**MONITORING YEAR 1
ANNUAL REPORT**
Final

BUG HEADWATERS MITIGATION SITE

Subject: MY1 Report Review
Bug Headwaters Mitigation Site, Wilkes County
Yadkin River Basin: 03040101
DMS Project ID No. 100084
DEQ Contract #7617

As-Built IRT Comments

Figure 1b. Current Condition Plan View
 Bug Headwaters Mitigation Site
 DMS Project No. 100084
 Monitoring Year 1 - 2021

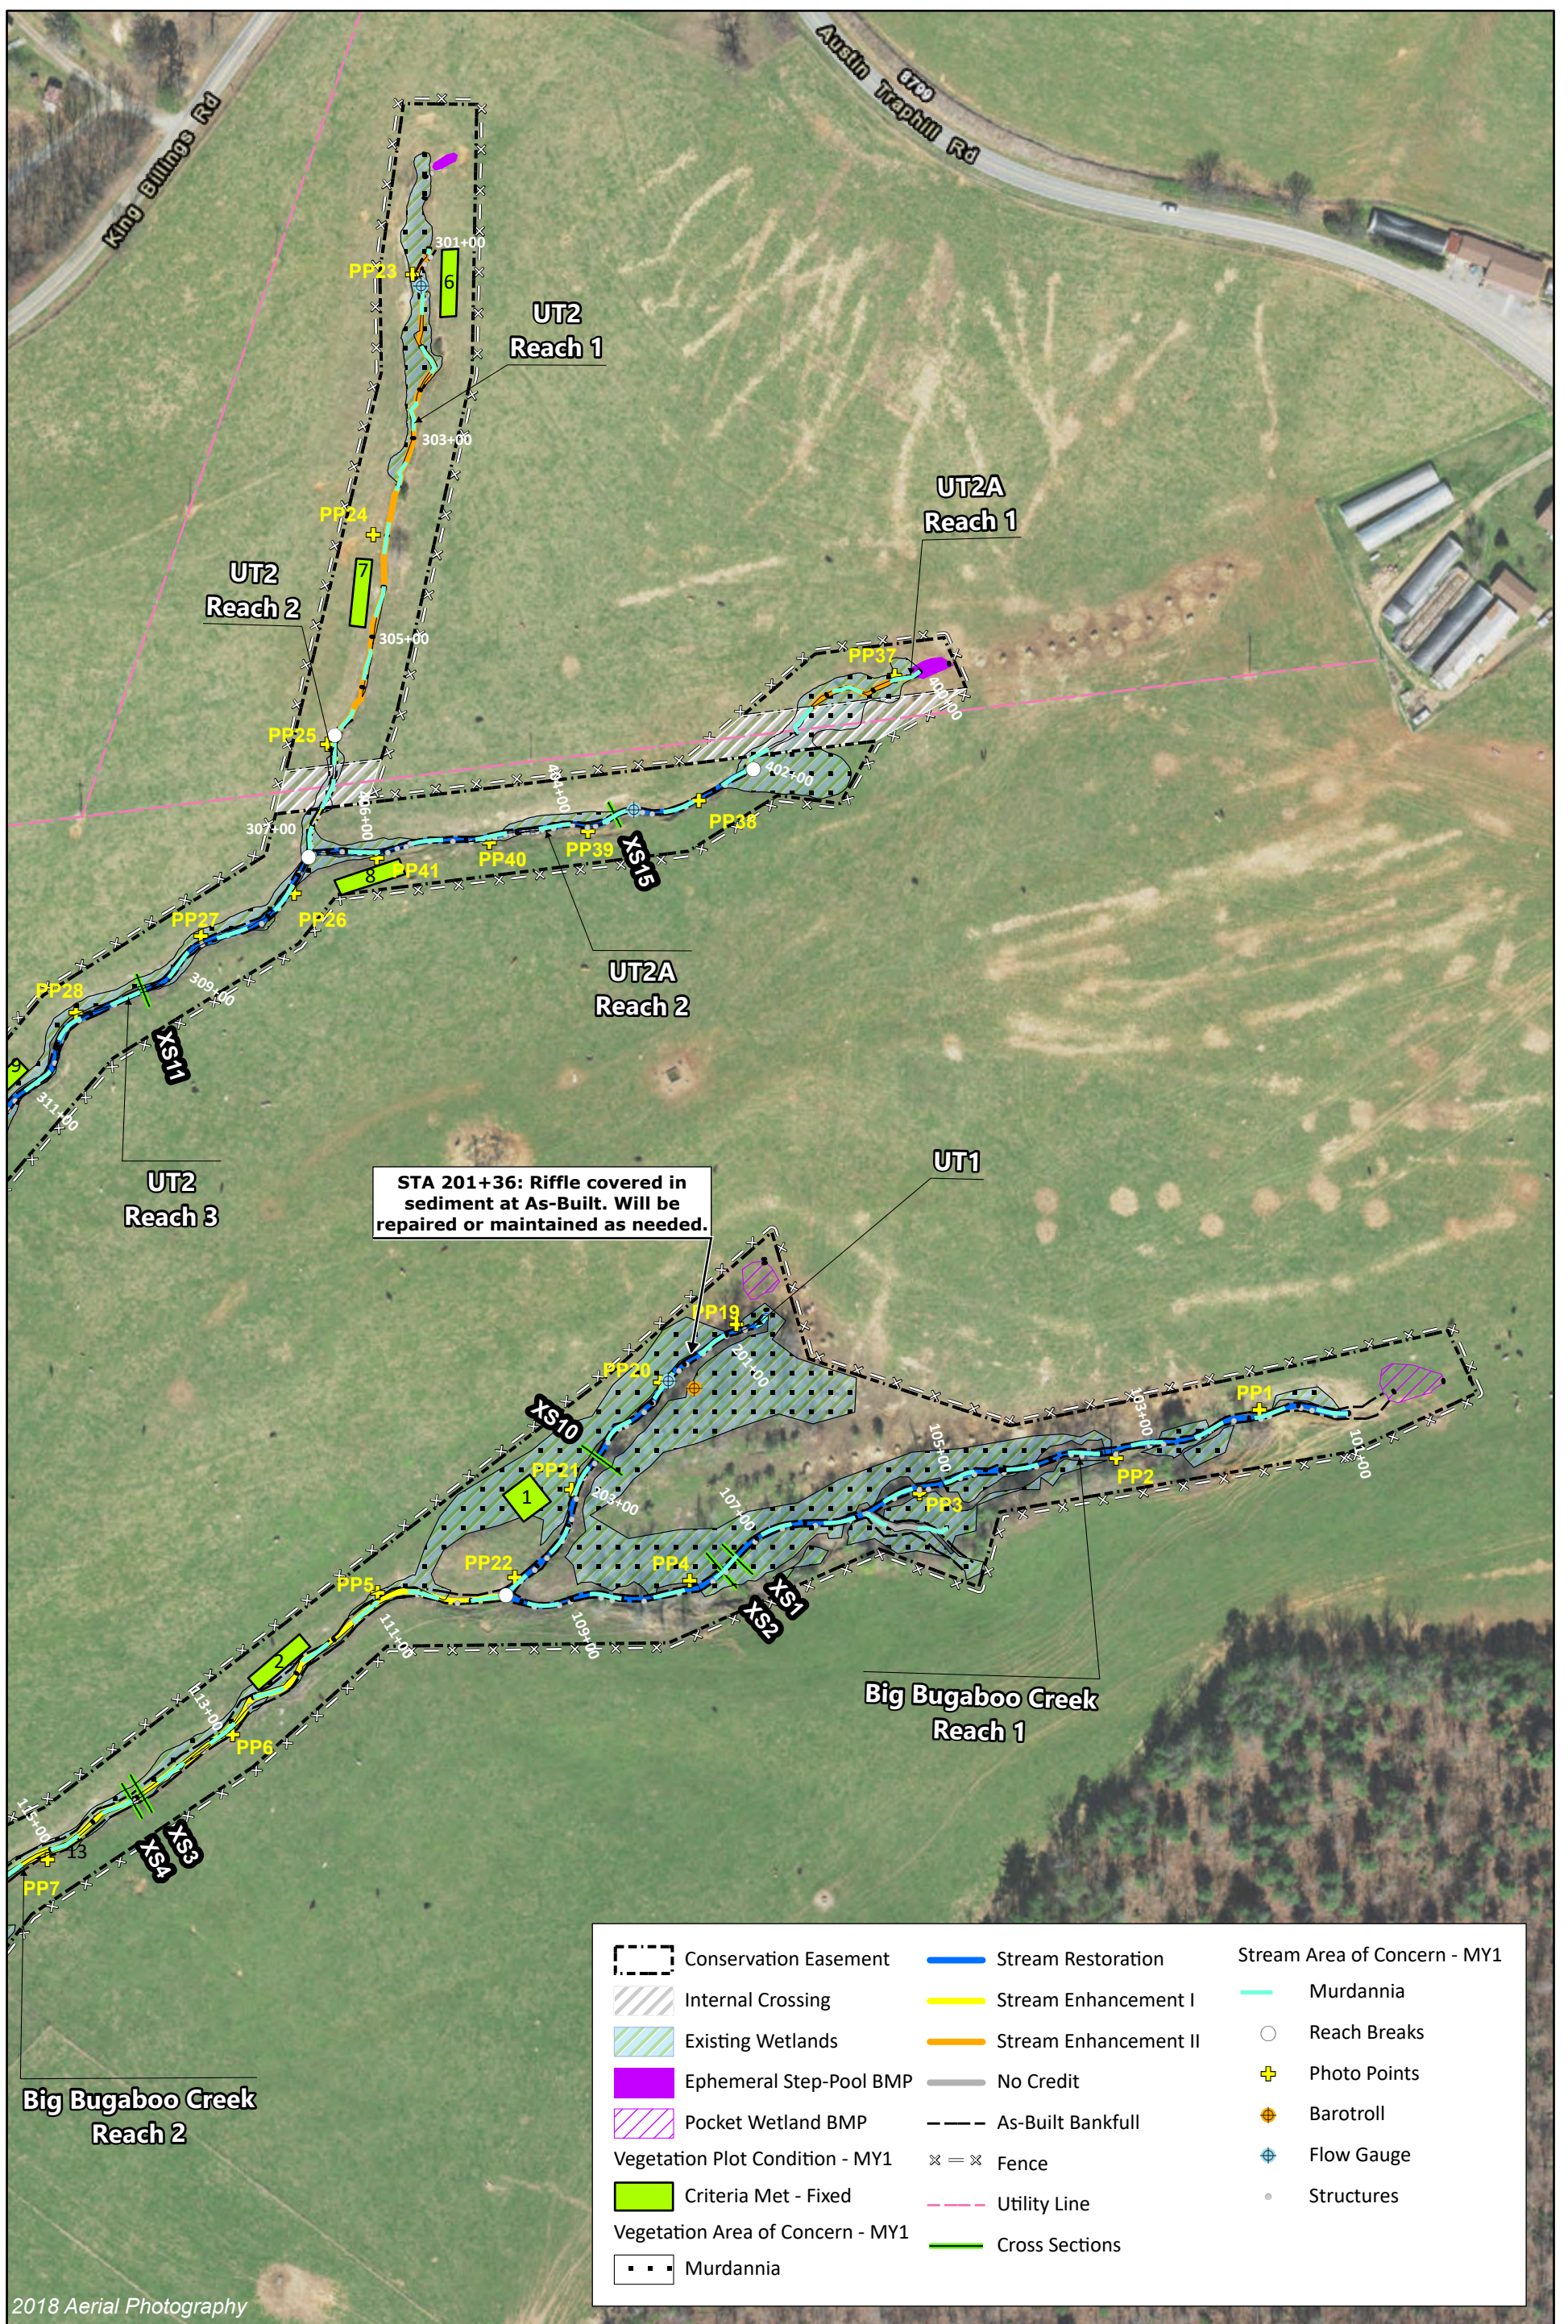
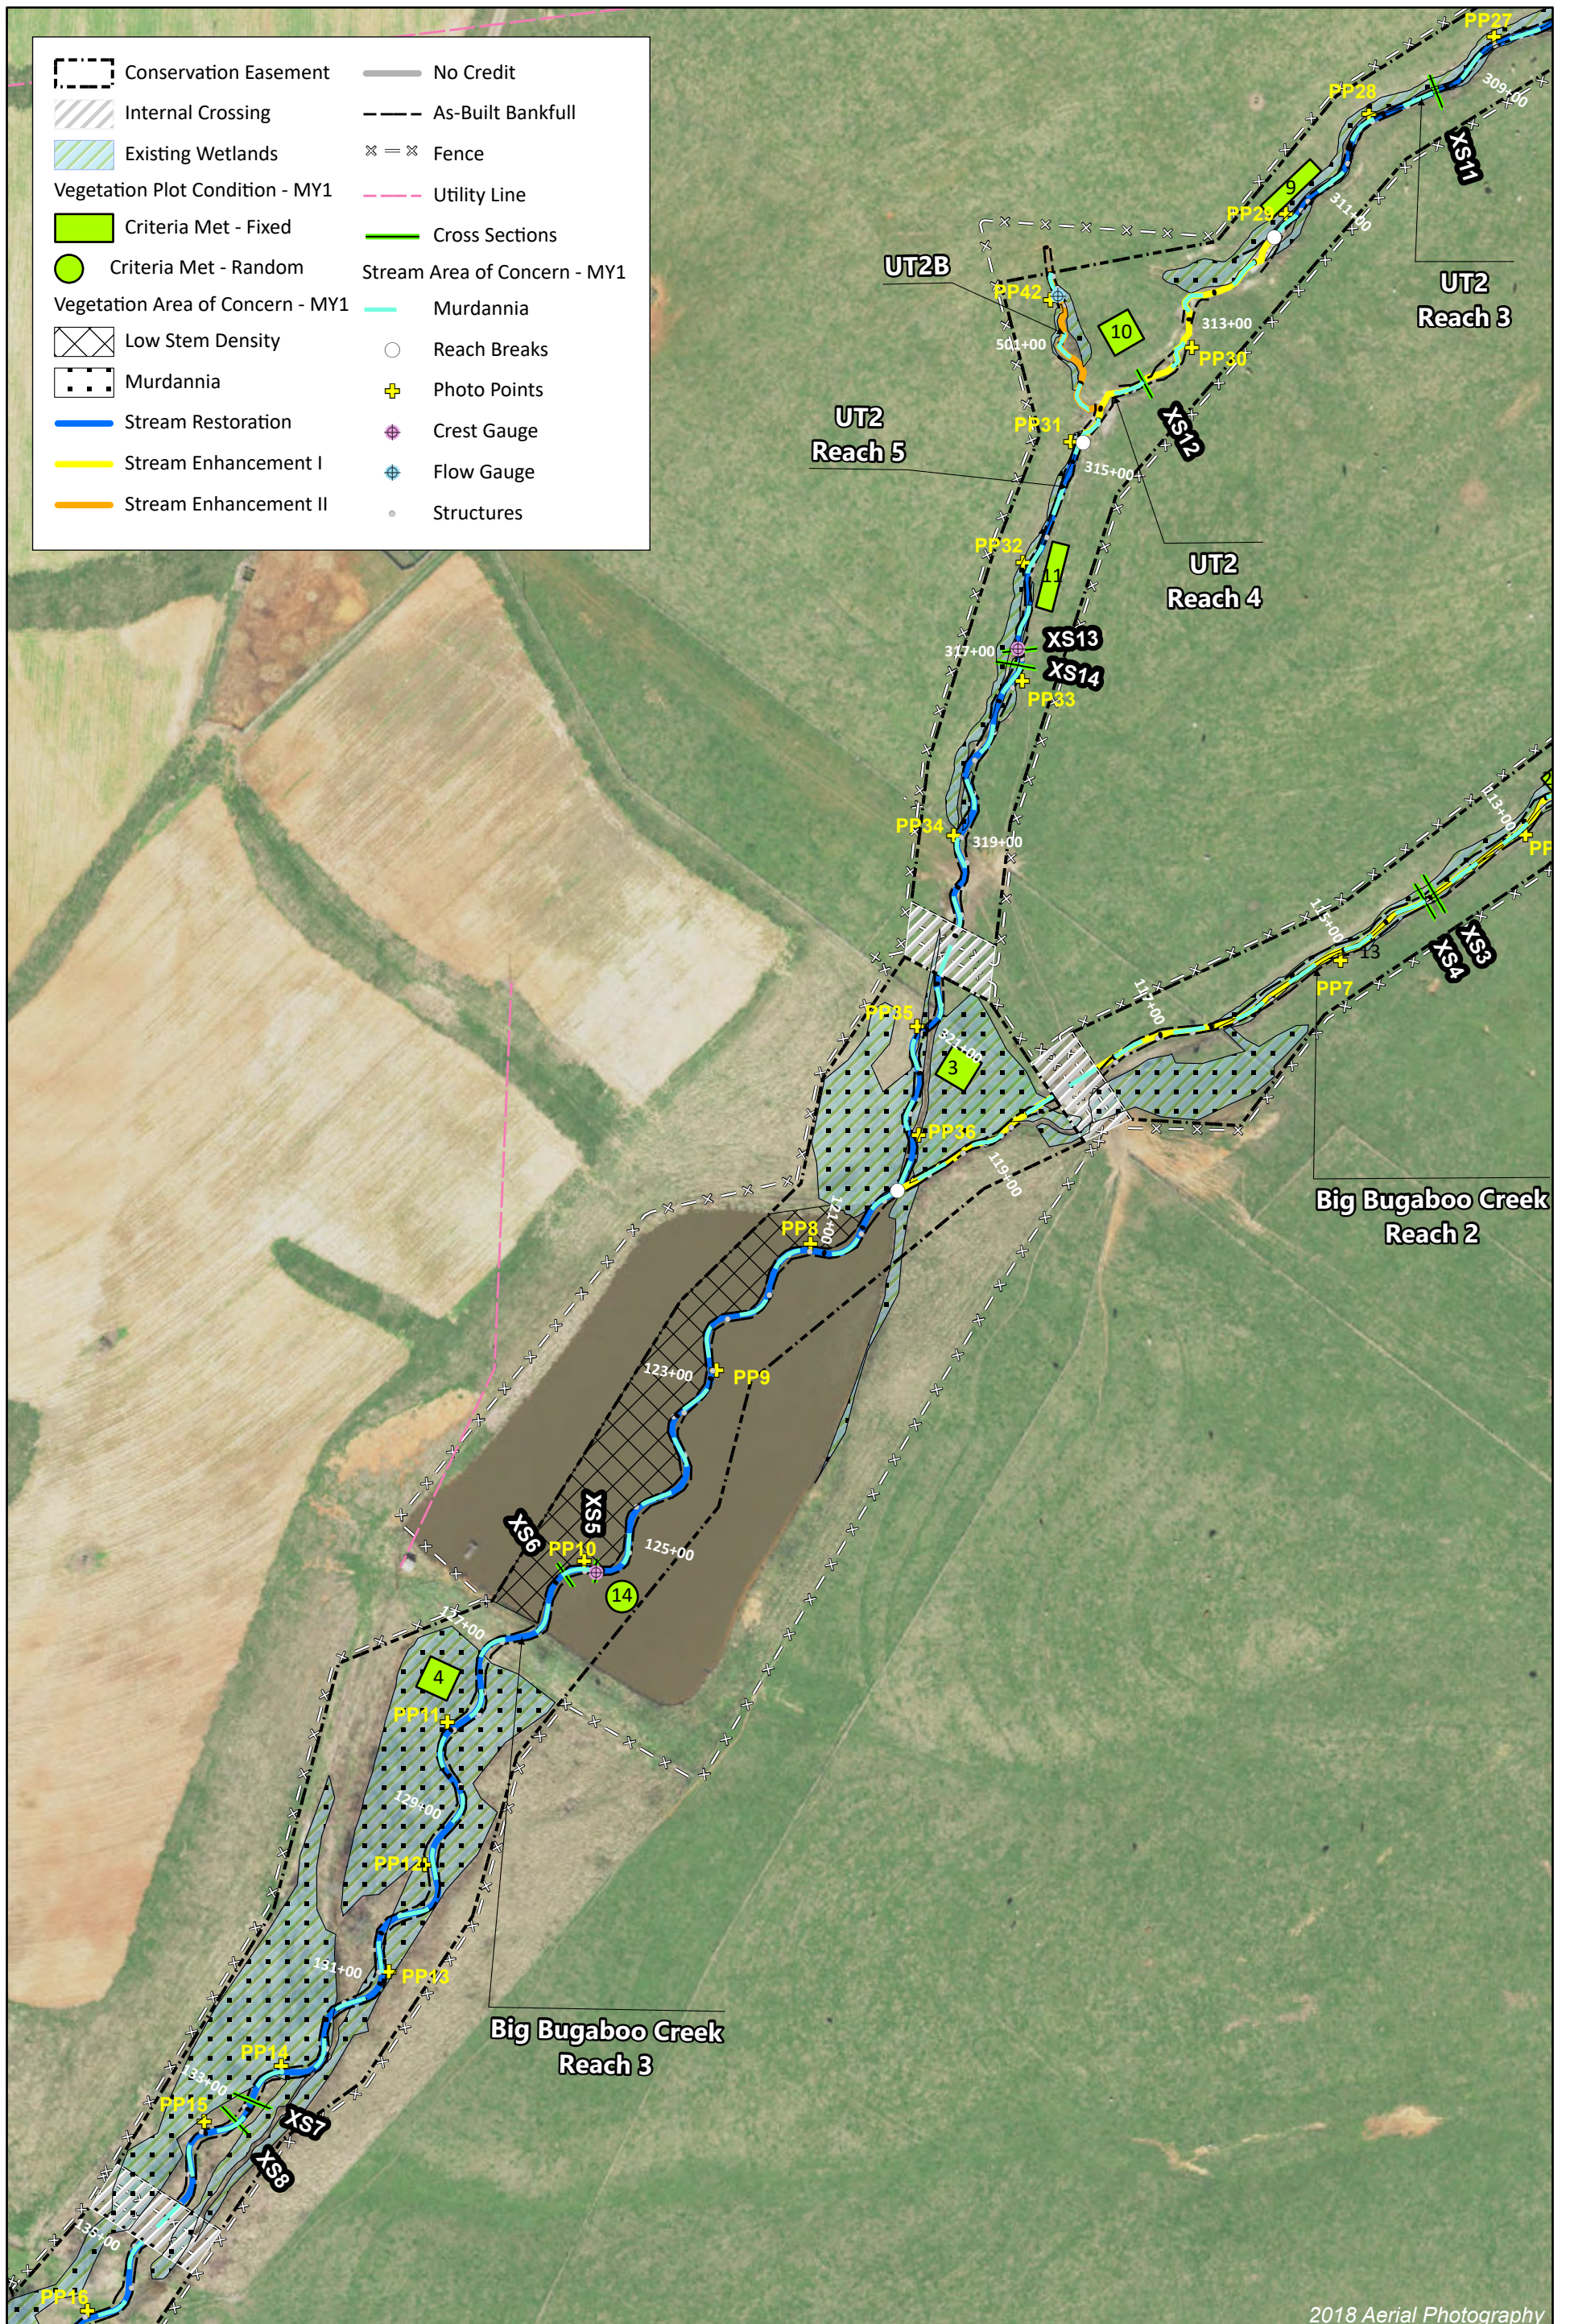
Murdannia is widespread on the site. All stream channels and wetlands are affected. DMS recommends discussing this problem with the IRT and developing an Adaptive Management Plan for this issue. This invasive species is aggressive and difficult to control and will likely be an ongoing issue throughout monitoring.

The MY1 assessment indicated only a small number of planted trees survived in the old pond bottoms along the right side of Big Bugaboo Creek Reach 3 and both sides of UT3 (Figure 1b-c). The visual assessment of the right side of Big Bugaboo Creek Reach 3 indicated some planted trees survived, but

Response: The IRT has been notified, and correspondence is located in Appendix F.

Supplemental planting will occur in the former pond bottoms along the right side of Big Bugaboo Creek Reach 3 and both sides of UT3. Due to saturated soil conditions, a mixture of bare roots and live stakes will be planted in the winter of 2022. While species selection will be dependent on nursery availability, the current plan includes black willow (*Salix nigra*), silky willow (*Salix sericea*), elderberry (*Sambucus spp.*), and button bush (*Cephalanthus occidentalis*) as live stakes and sycamore (*Platanus occidentalis*),
